CITY OF KELOWNA
MEMORANDUM

Date: April 4, 2001
File No.: Z01-1008

APPLICATION NO. Z01-1008 OWNER: Board of School Trustees
School District #23 (Central
Okanagan)
AT: 805-815, 895 Craig Road, 621 APPLICANT: Judy Shoemaker,
Hartman Road, and 650 Webster Supervisor of Planning
Road

PURPOSE: To rezone four properties south of Hartman Road and east of Craig Road to allow for the construction of a Public School.

The site is indicated on the map below.

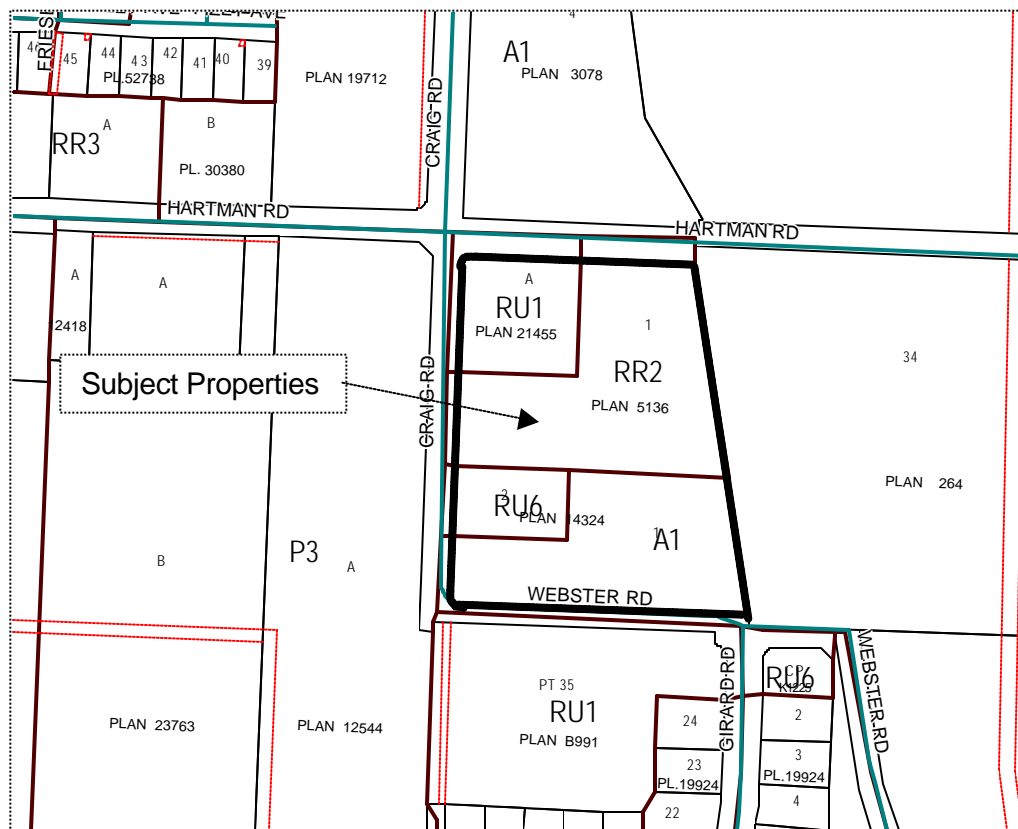
Note: The Transportation Division has requested that the bicycle parking be increased to a minimum of 4.0 stalls per classroom to accommodate the students living within cycling distance to the school.
